**FILE NUMBER:** Z190-158(RM) **DATE FILED:** December 6, 2019

**LOCATION:** Northeast corner of Gulden Lane and Singleton Boulevard

**REQUEST:** An application for a Planned Development District for office and mixed uses on property zoned an IR Industrial Research District.

**STAFF RECOMMENDATION:** Approval, subject to a revised development plan, a revised streetscape exhibit, and staff's recommended conditions.

## APPLICANT'S PROPOSED DEVELOPMENT PLAN (ENLARGED)

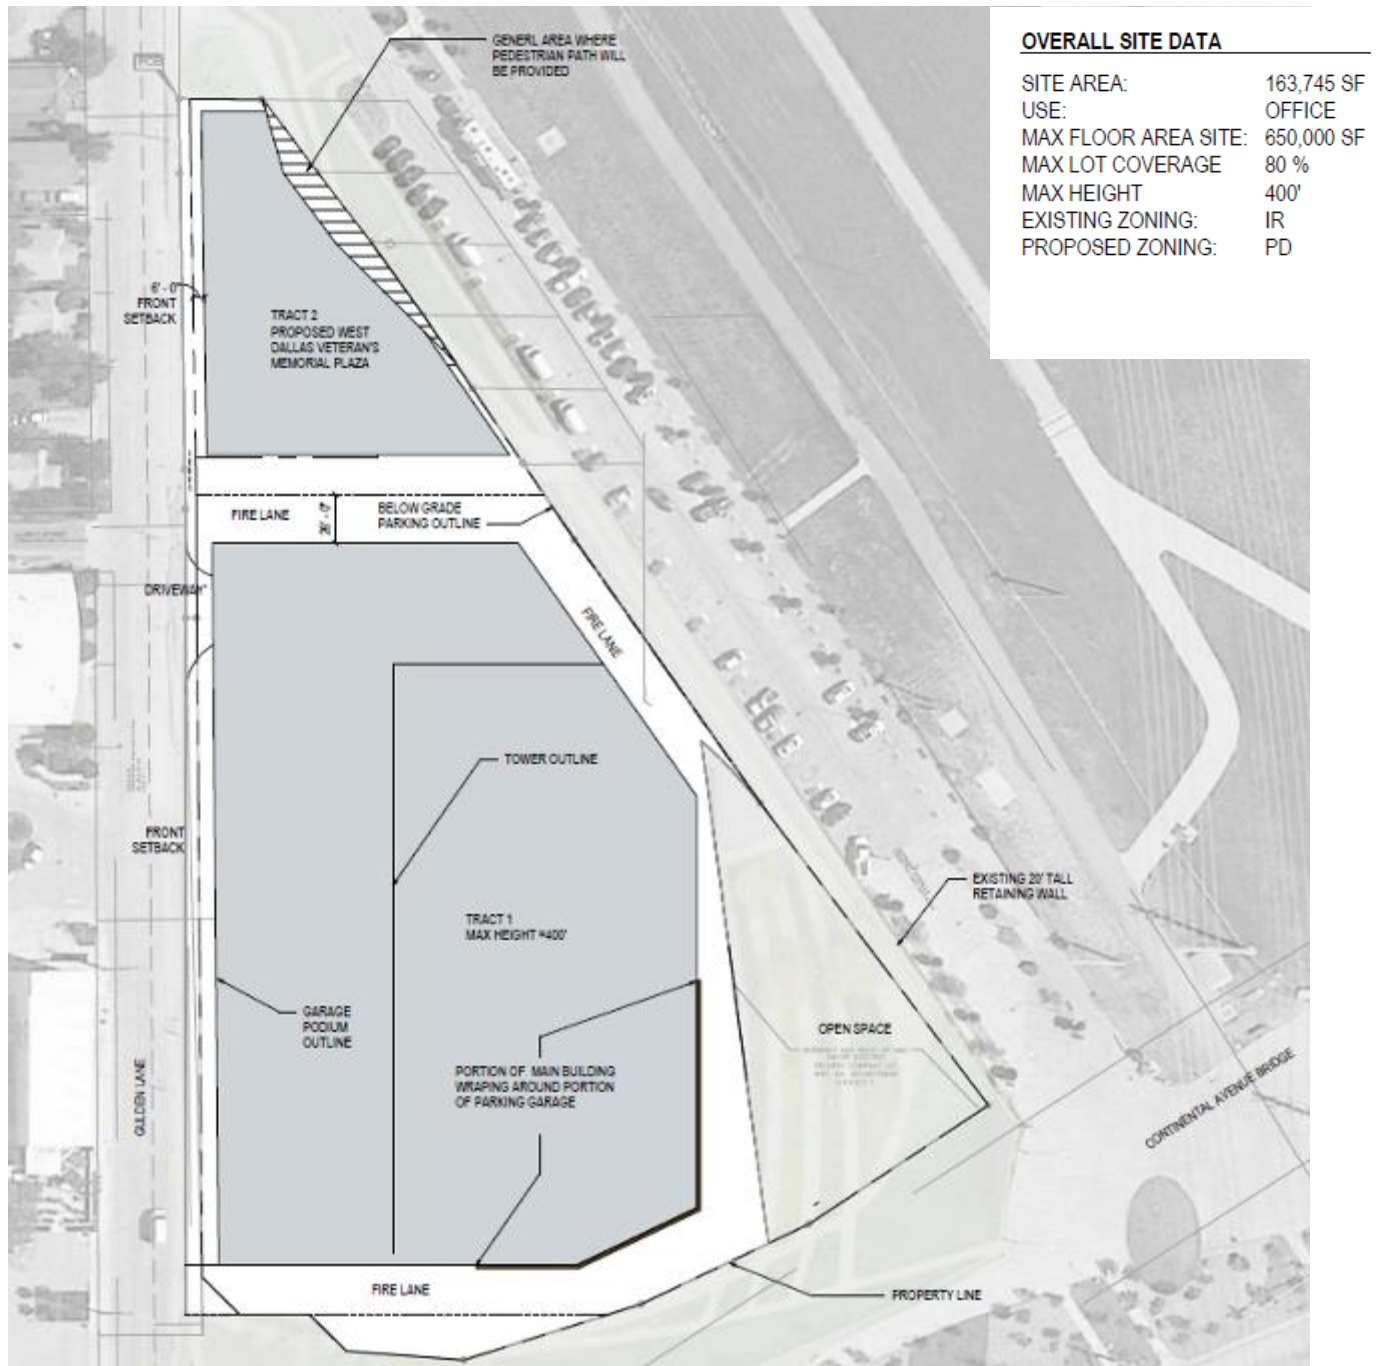
- 10) Allow shared improvements between Tract 1 and Tract 2 consisting of driveways, paved areas, fire lanes, and similar horizontal improvements.
- The proposed development plan has been revised to reflect a wider and longer pedestrian path, an open space area along the southeastern portion of the site, and the conditions have been revised removing the request for district identification signs and roof signs. The City Attorney Office, CAO has outlined concerns with roof tops signs, requested in PDs. As a result of the determination, rooftop signs are now limited to district identification signs, as an alternative. Staff does not support the inclusion of the open space due to the location along a major arterial road and the open space encroaching into a required 26-foot-wide fire land that encircles the development and prevents the open space from containing pedestrian amenities.

- As requested by the Commission, the development plan fails to provide an elevation for the office tower or garage podium and/or a varied height plan (like Z190-180) to better determine how the proposed height would be staggered with the maximum height moving east and away from the residential properties.

**APPLICANT'S PROPOSED STREETSCAPE EXHIBIT**

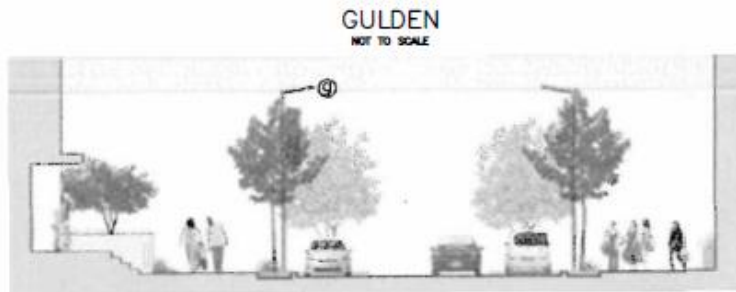
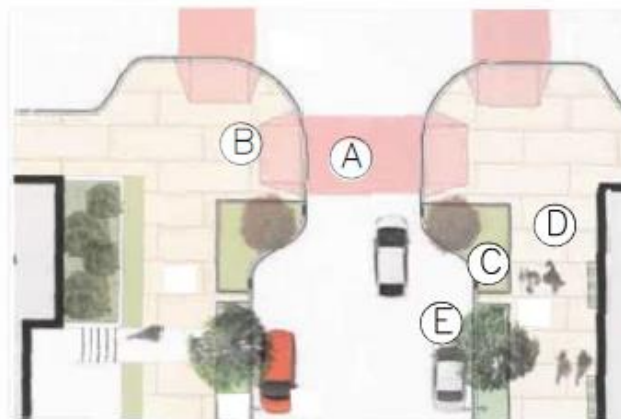
- 6) deviating from the streetscape standards as required by the West Dallas Urban Structure and Guidelines Area Plan (the Structure);
  - 7) allow Tract 1 and Tract 2 to be considered as one lot when calculating the floor area ratio;
